TOWN OF JAMESTOWN
ZONING BOARD OF REVIEW

TO: Jamestown Zoning Board of Review
FROM: Michael Swistak, Chair and
The Jamestown Planning Commission
RE: Motion for Zoning Section 82-314: High Groundwater
Table and Impervious Overlay District, Sub-District A –
Mark D'Arezzo and Esther Pederson: AP 15, Lot 286; 141
Beacon Avenue, Jamestown, RI
DATE: September 21, 2020

**SOIL EROSION & SEDIMENTATION
CONTROL PLAN**

for
**141 BEACON AVE
AP 15 LOT 286**

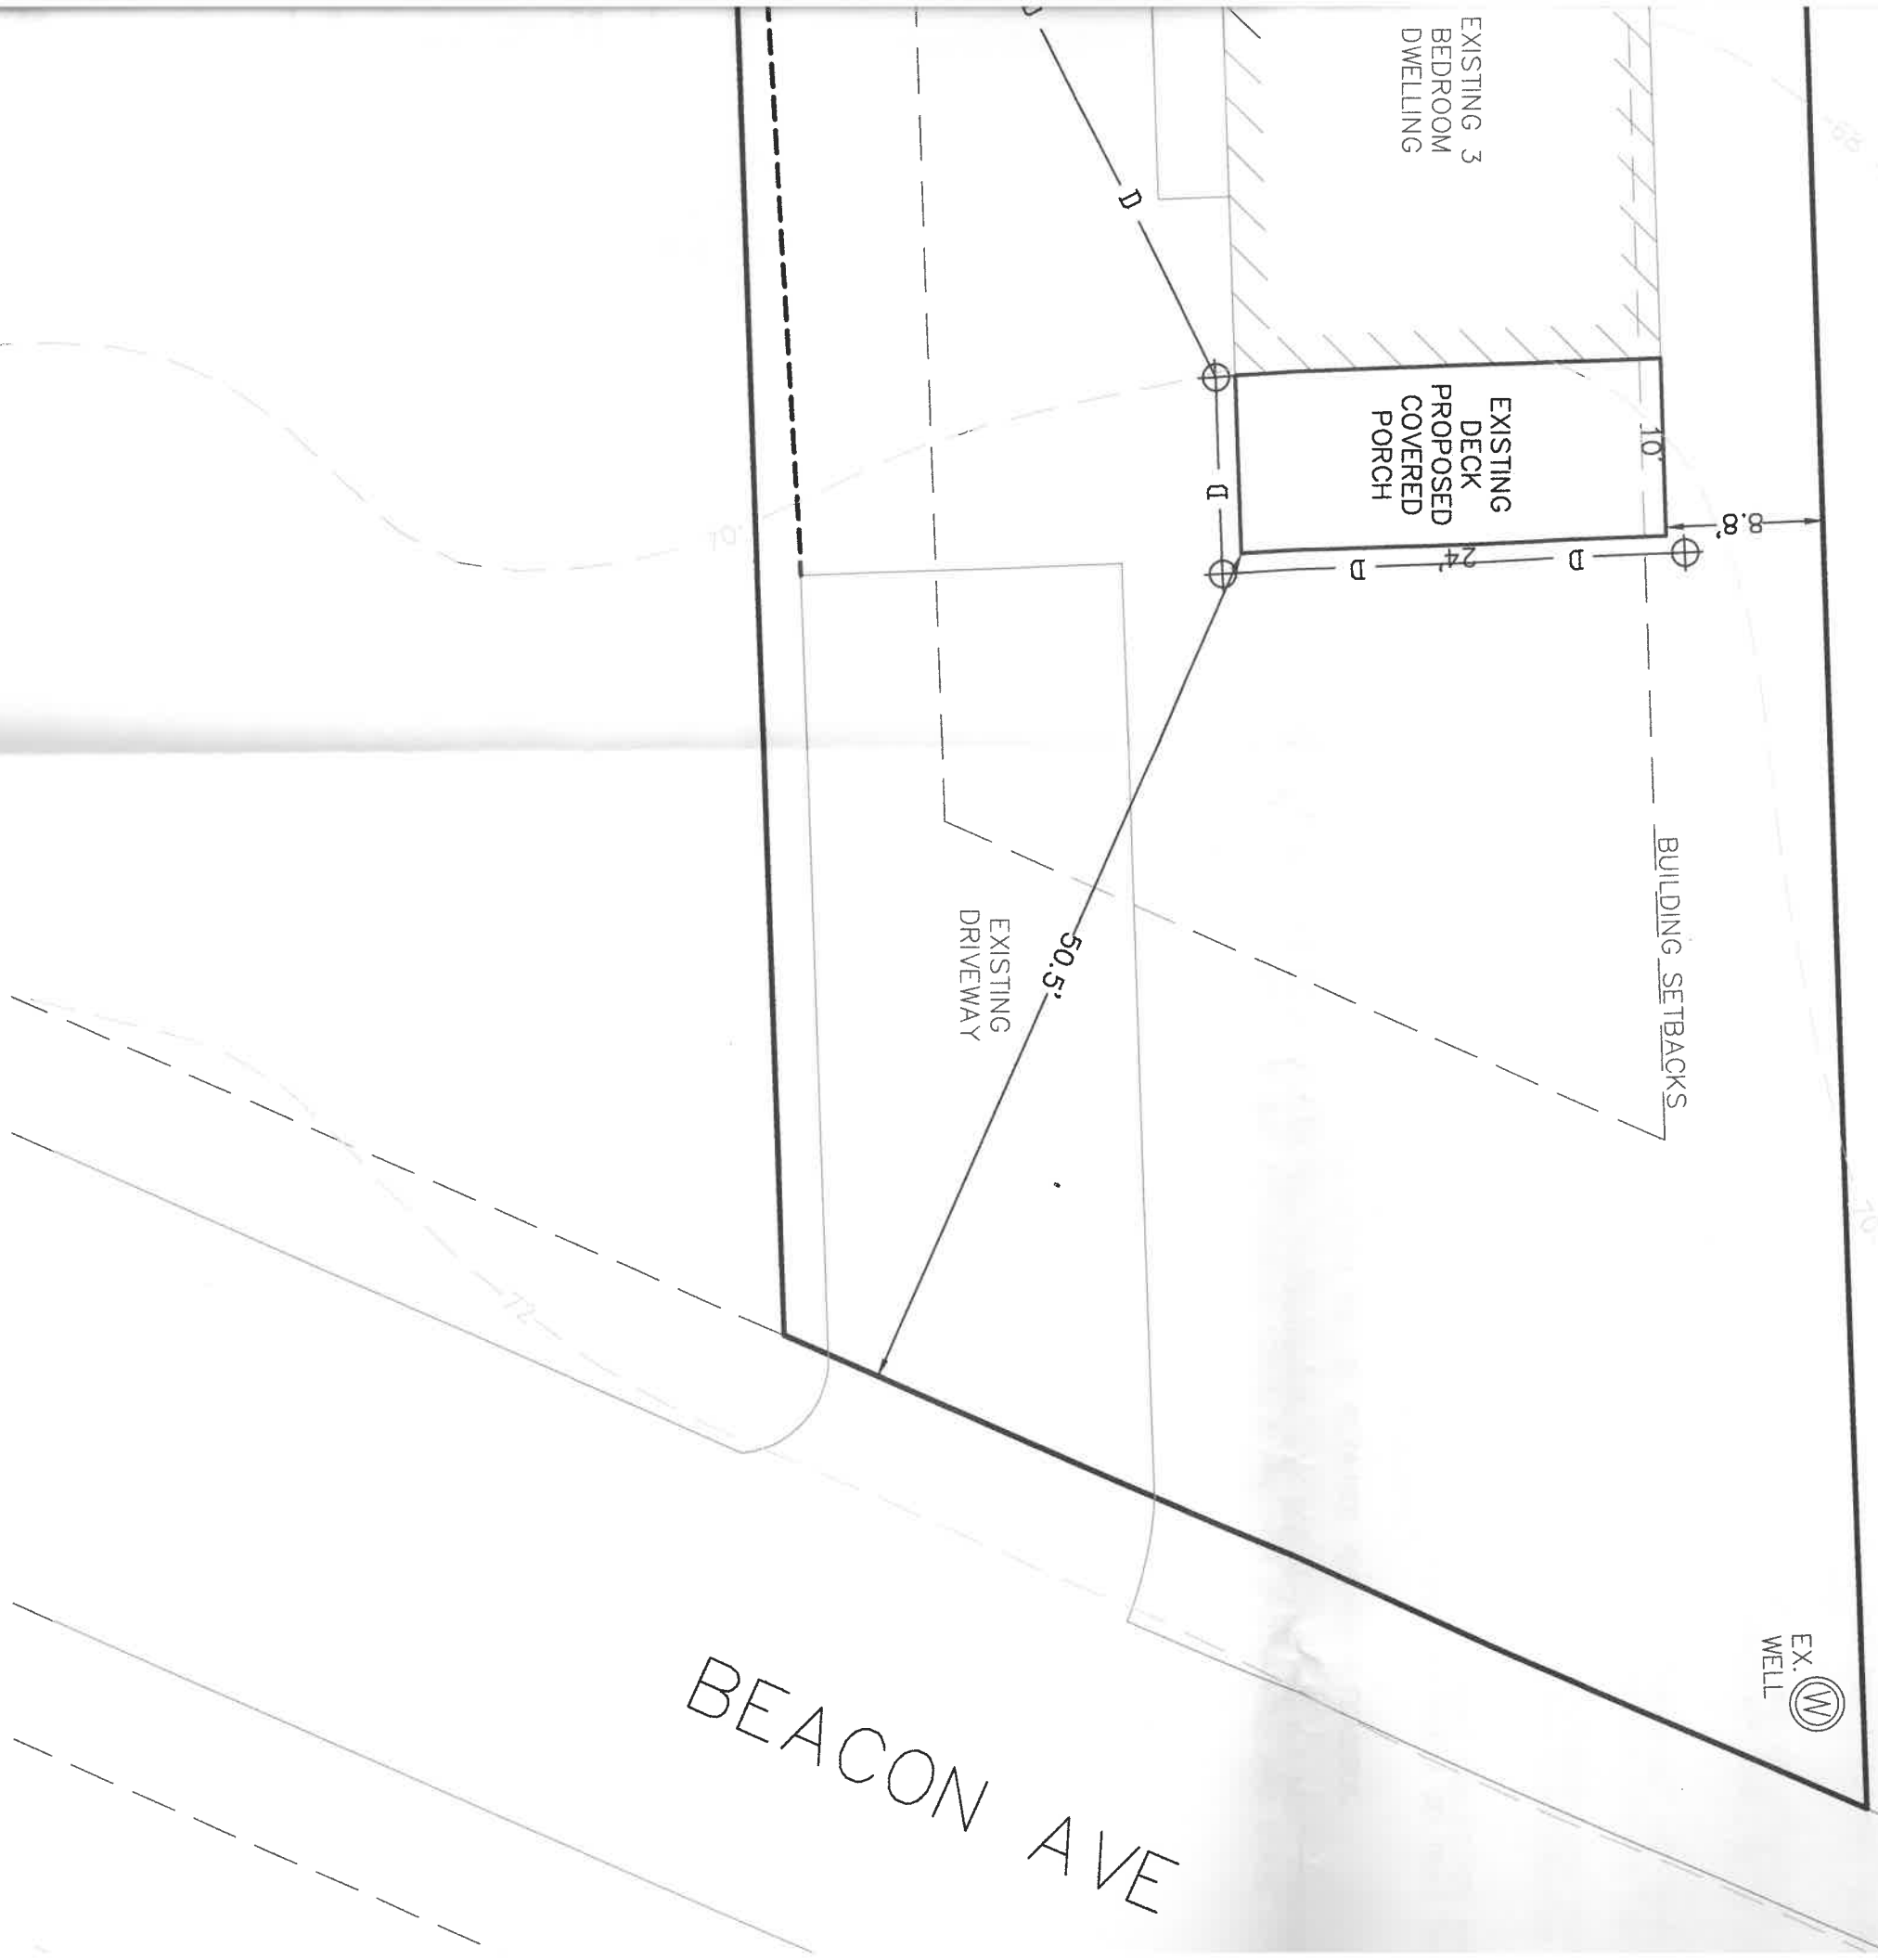
1. The property is 10,380 square feet (sf) in area;
2. The existing site is developed with a house, driveway, well, and an advanced treatment OWTS (Septi-tech to bottomless sand filter);
3. Existing impervious cover is approximately 1,056 sf or 10.2%.
4. The Town database indicates that the OWTS was installed in February 2020 and is current for maintenance;
5. Topography on the lot slopes from east to west on the site;
6. There are no freshwater wetlands on the property;
7. The Applicant is proposing to construct a 240 square foot covered porch over an existing deck;
8. The soil evaluations results show that the site falls under **Sub-district "A"** requirements of the High Groundwater Table and Impervious Layer Overlay District with 22" to the seasonal high-water table and 39" to impervious soil.
9. The maximum impervious cover allowed is 13% or 1349 sf.;

10. The total proposed impervious cover will be **1,296 sf or 12.5%**;
11. The existing well and OWTS will remain;
12. A rain garden is proposed to provide water quality treatment and stormwater mitigation of new rooftop runoff. The required stormwater treatment volume for the new rooftop is 78.4 cubic feet (cf) and 84 cf is provided in the proposed rain garden.;
13. The applicant's representative James Traglia of Principe Co, Inc, was present at the Planning Commission meeting and represented the applicant before the Planning Commission on 9-16-20;
14. Jamestown Engineer Jean Lambert provided correspondence to Chris Costa, Building Official and Lisa Bryer, Town Planner dated September 10, 2020 regarding the D'Arezzo-Pederson application (attached).

1. An erosion and sediment controls must be installed at the down gradient limits of site disturbance and maintained until stabilization of the site is attained;

2. Maintenance and inspection of the existing OWTS shall continue as required by the Town Onsite Wastewater Management Ordinance;
3. The rain garden shown on the approved site plans must be installed and maintained as outlined on the rain garden noted on the approved site plan;

4. The Operation and Maintenance (O & M) Plan (reproduced in 8.5" x 11" for the stormwater mitigation (rain garden) shall be recorded in the Office of the Town Clerk with the Zoning Approval and evidence of such shall be provided to the Zoning Enforcement Officer as well as the Planning Department; and,

5. Any additional future site work including a change to the driveway surface that increases the area of impervious coverage will require a review following the requirements of the High Groundwater Ordinance.
